**FORD:** 1995-1996 ECONOLINE, F SUPER DUTY, F-250, F-350

Some changes and updates have been incorporated into the 1996 model year 7.3L DIT engine.

**Article No. 96-11-13 Cont'd.**

Figure 1 - Article 96-11-13

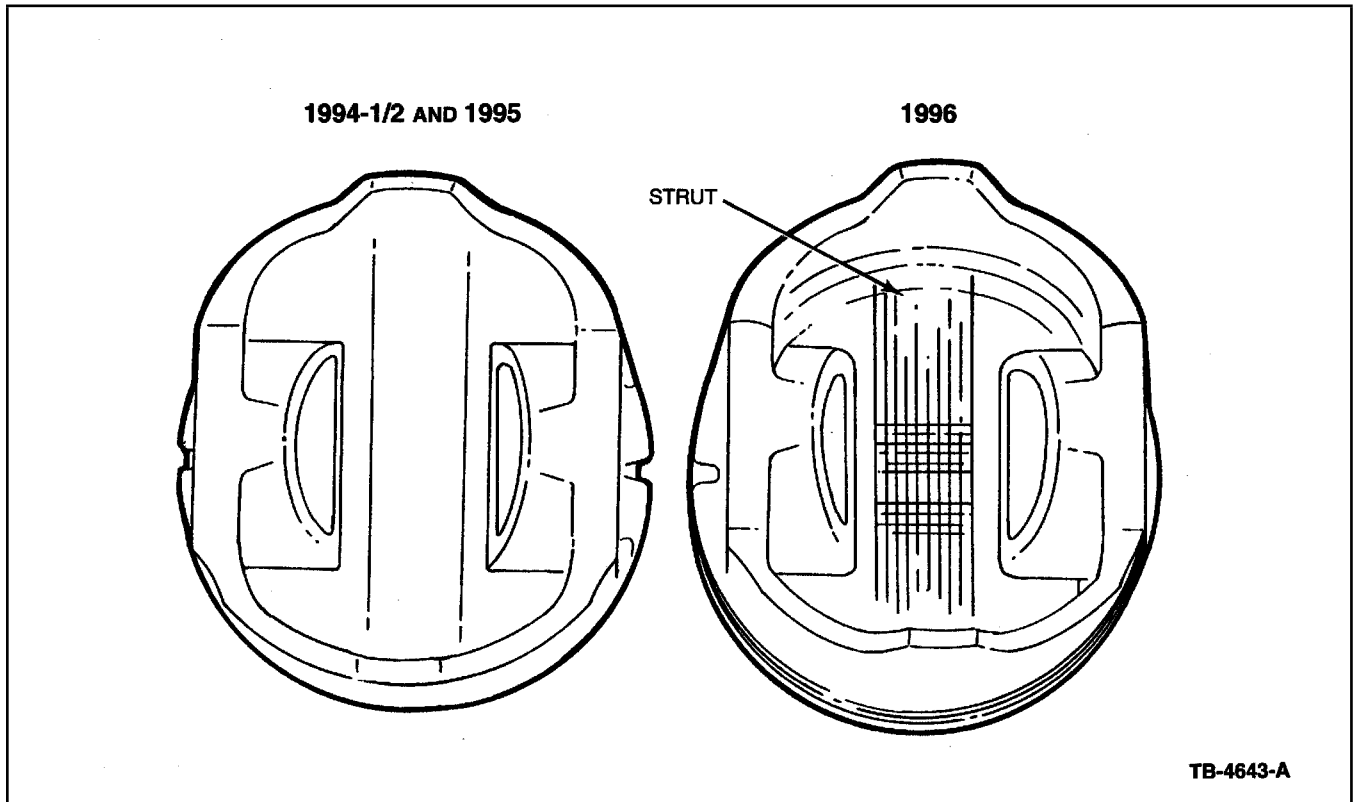
- New piston struts which control piston expansion and higher tension rings provide better seal and tighter clearances. Figure 1.
- New laminated steel valve covers with a middle layer of insulating polymer.
- New California injector for rate shaped injection for cleaner, quieter burn.

Figure 2 - Article 96-11-13

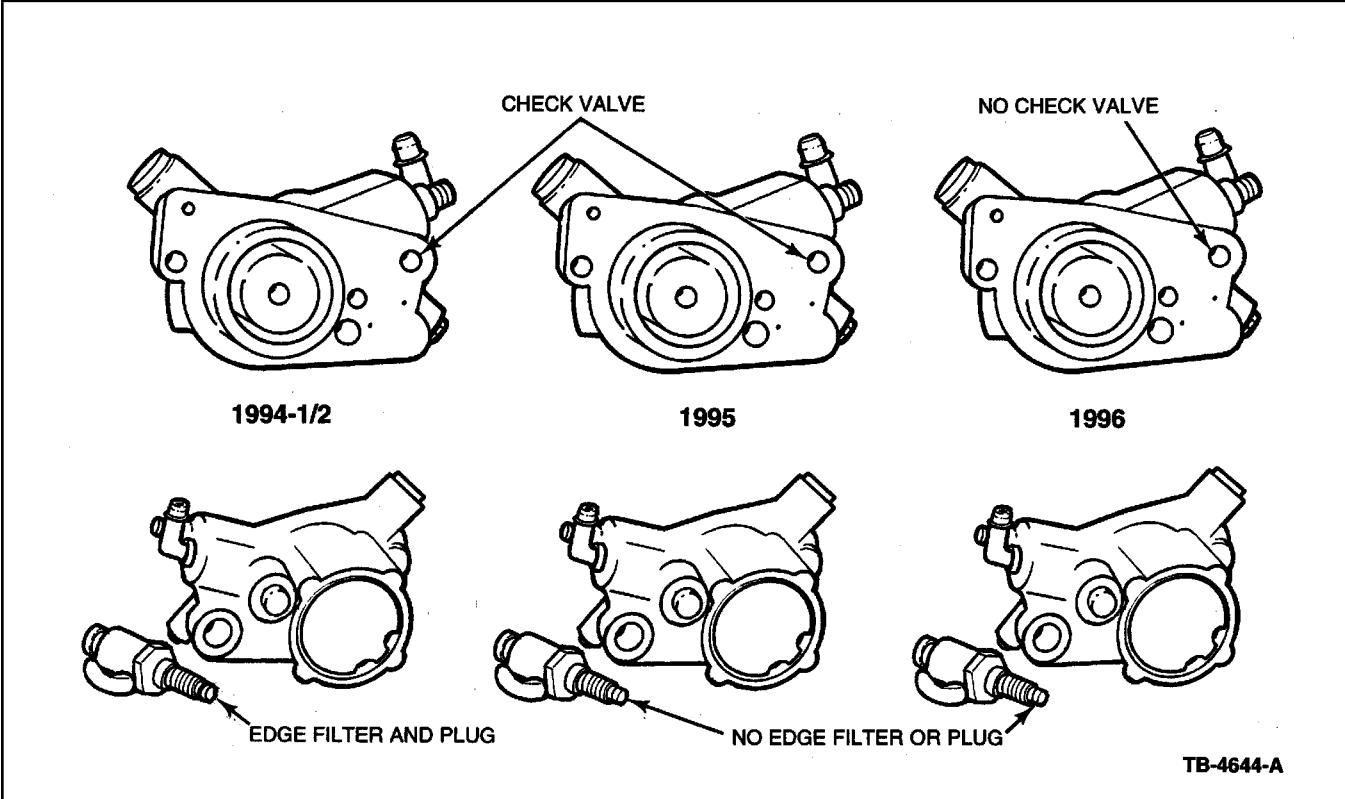
- Drain check valve deleted in high pressure pump. Figure 2.
- Integral edge filter incorporated into high pressure pump (starting with #187100). Figure 2.
- IPR valve deleted edge filter (starting with #187100). Figure 2.

**THE 1994 IPR CANNOT BE USED IN THE 1995-96 NEW HIGH PRESSURE PUMP. WHEN REPLACING HIGH PRESSURE PUMP OR IPR FOR ANY REASON, BE SURE TO CHECK THE PART IDENTIFICATION NUMBER TO ENSURE COMPATIBILITY.**

Figure 3 - Article 96-11-13

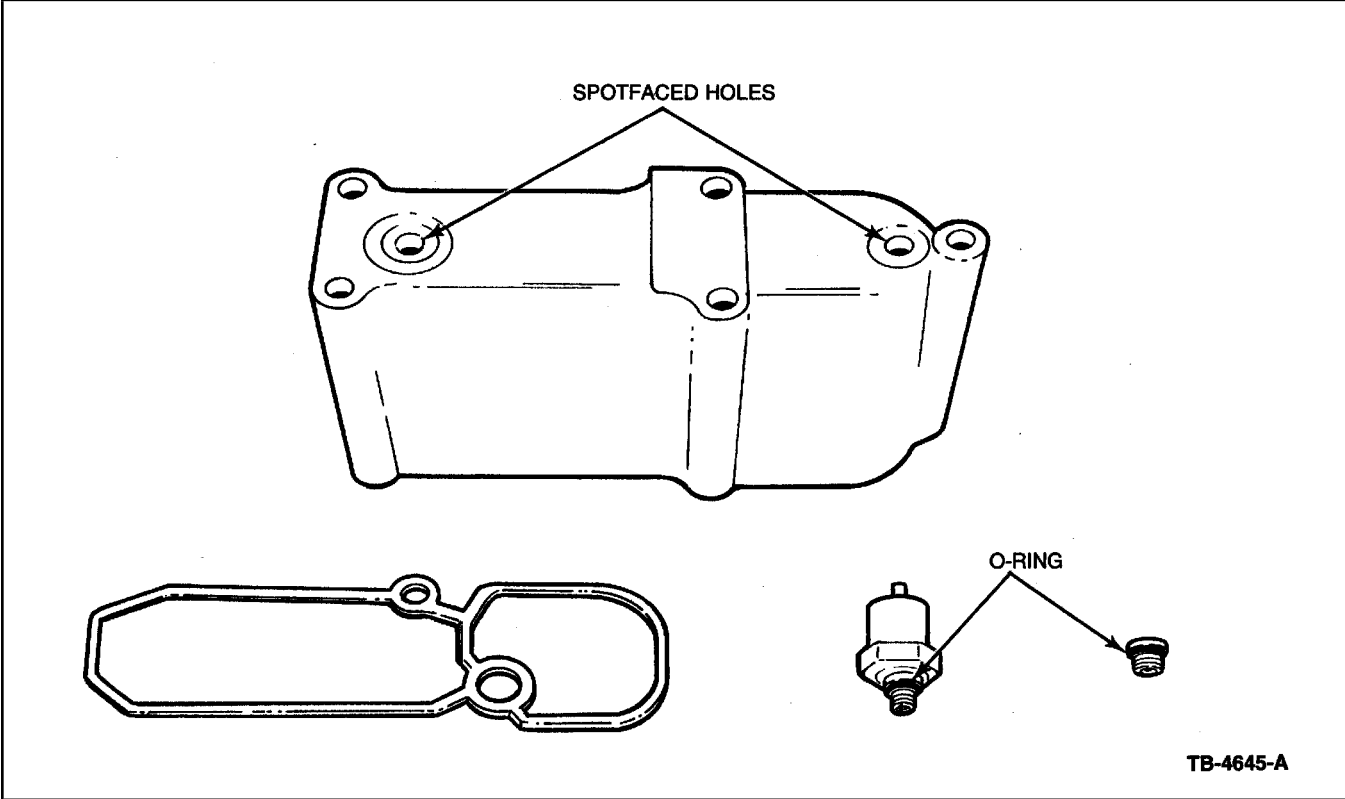
- New reservoir includes anti-drainback standpipe and new straight thread, O-ring sealed oil pressure sensor and inspection plug. Figures 3 and 4.
- New high pressure pump gasket to seal the standpipe chamber between the front cover and the pump. Figure 5.
- New reservoir-to-front cover gasket which replaces RTV. Figure 6.
- New front cover modified to accommodate reservoir gasket and passages have been cast and drilled to incorporate the standpipe.
- A new de-aeration device added to the front cover includes a check ball which allows air to escape from the oil. It is mounted between the lube oil pump and oil cooler on the inside of the front cover. Figure 7.

Figure 8 - Article 96-11-13

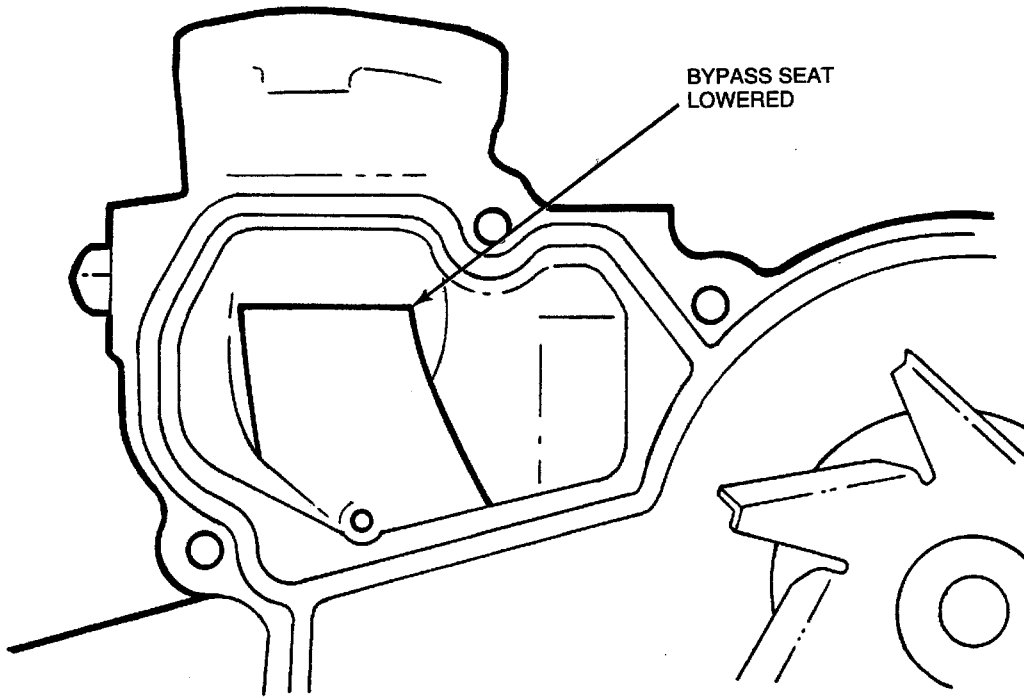
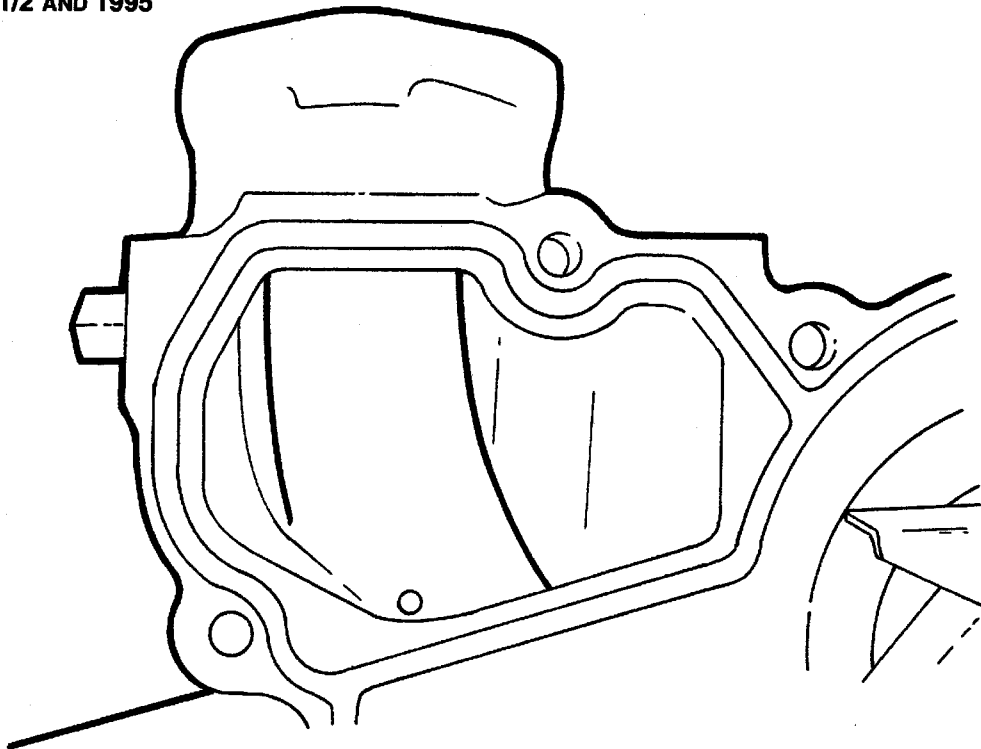
- Water pump bypass seat lowered to improve thermostat bypass flow and decrease pressure below the thermostat. Figure 8.
- Heater return fitting is now straight thread and O-ring sealed. Figure 9.
- New thermostat is longer and opens at a lower coolant temperature (89°C instead of 95°C/192°F instead of 203°F) to allow engine to operate at lower temperatures. Figure 10.

Figure 11 - Article 96-11-13

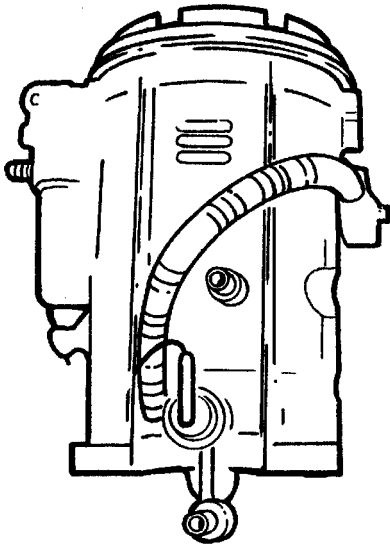
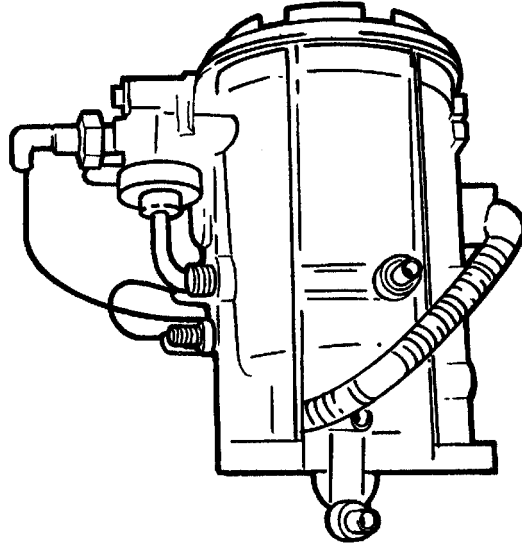
- Plastic cup on fuel filter pressure regulator has been deleted. Figure 11.
- New turbo inlet manifold hoses have deleted the hump. Figure 12.
- Automatic transmission flywheel thickness is increased for strength.
- Deleted wear sleeve on crankshaft rear seal (production only, service parts still use wear sleeve).
- Powertrain Control Module (PCM) software to improve idle performance and enhanced cylinder contribution test (test is longer in duration).
